ORIGINATION FORM

Proposed Revisions to a Standard Plans Index
(Please provide all information – Incomplete forms will be returned)

Index Number: **700-030**
Sheet Number (s): 1
Index Title: Wind & Hanger Beams for Overhead Signs (was Overhead Sign Panels)

SIDE ELEVATION

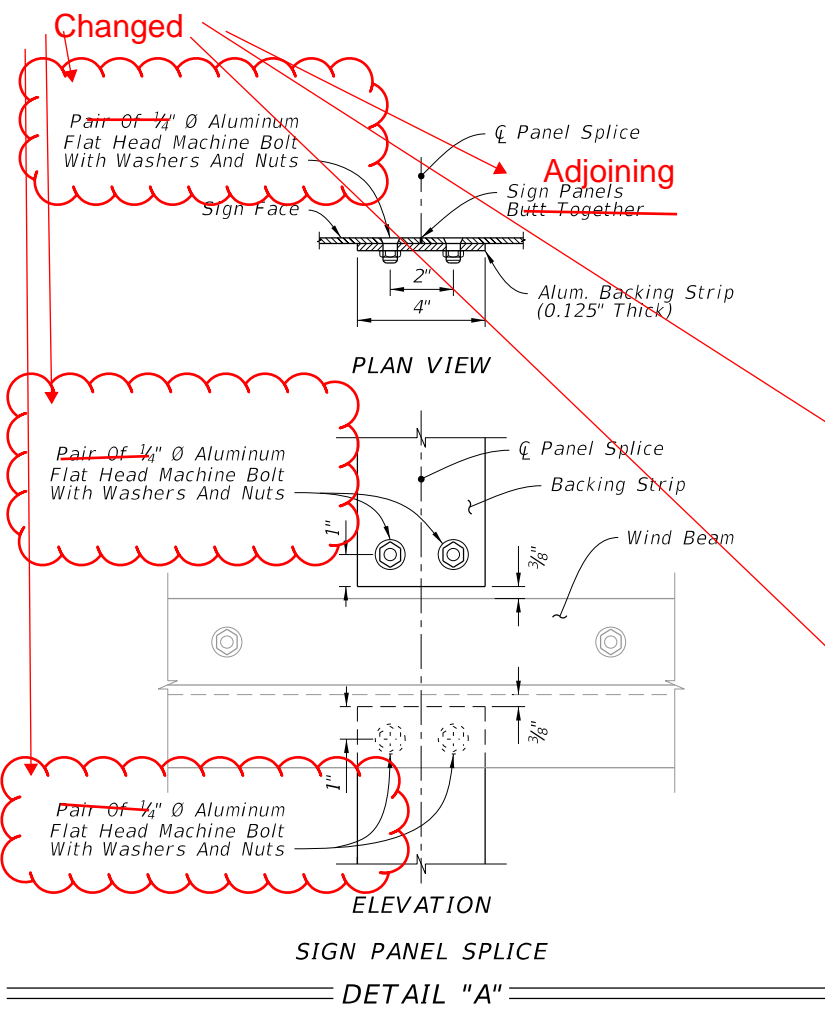
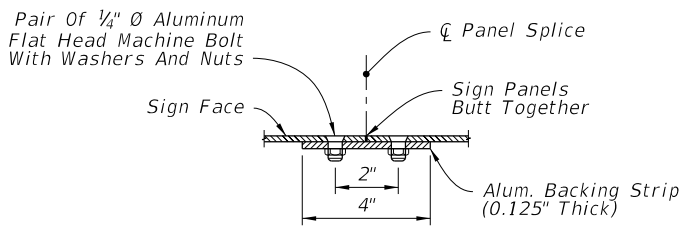
Changed the Title; Separated current table into two tables. Changed Note 8. Deleted Maximum chord spacing from SIDE ELEVATION. Changed % spacing for hangers; Changed to flat washers

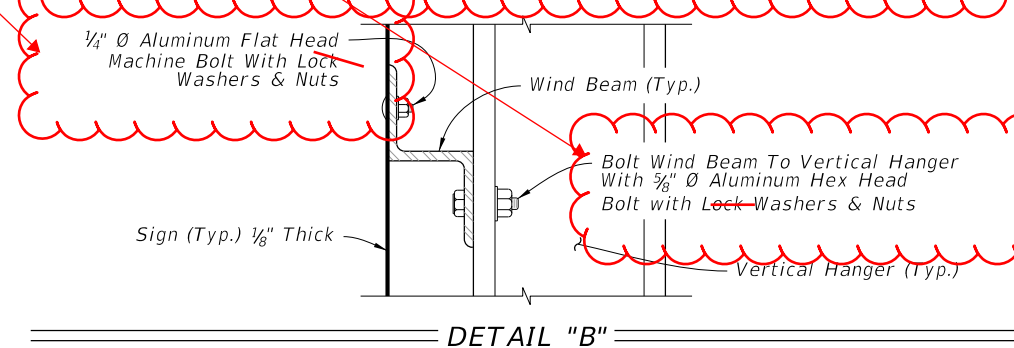
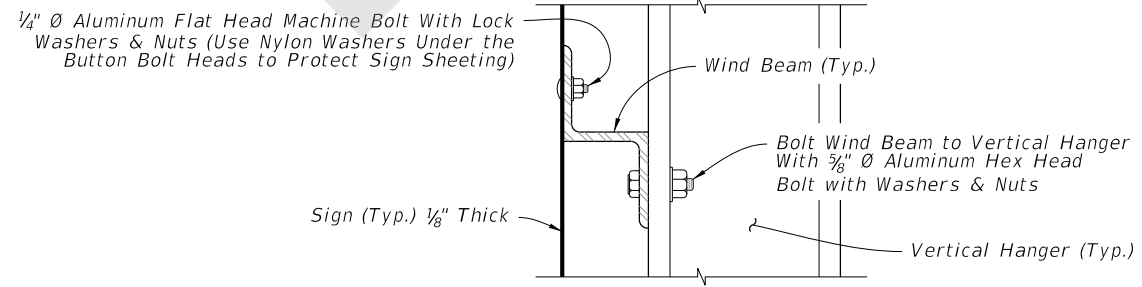
Title was changed to better describe what is covered in the Standard. To clarify requirements of wind beams vs hangers table is separated and updated as necessary. Additional hanger requirement was added for 180 mph wind zone.

WIND BEAM TABLE (Z 3 x 2 1/16 x 2.33)

Number of Horizontal Wind Beams Based on Sign Depth (D)

2 Beams	3 Beams	4 Beams	5 Beams	5 Beams
D ≤ 5'	5' < D ≤ 9'	9' < D ≤ 12'	12' < D ≤ 15'	15' < D ≤ 18'

HANGER TABLE (I 6 x 4.69 or Z 5 x 3 1/4 x 6.19)

Number of Vertical Hanger Beams Based on Wind Speed and Sign Length (L)

2 Hangers	3 Hangers	4 Hangers	5 Hangers	6 Hangers
130 mph	L ≤ 20'	20' < L ≤ 30'	30' < L ≤ 40'	40' < L ≤ 50'	--
150 mph	L ≤ 18'	18' < L ≤ 27'	27' < L ≤ 35'	35' < L ≤ 45'	45' < L ≤ 50'
170 mph	L ≤ 15'	15' < L ≤ 20'	20' < L ≤ 28'	28' < L ≤ 35'	35' < L ≤ 43'

NOTE: For Monroe County designs, use 170 mph values but with Z 5 x 3-1/4 x 6.19 vertical hanger beams only.
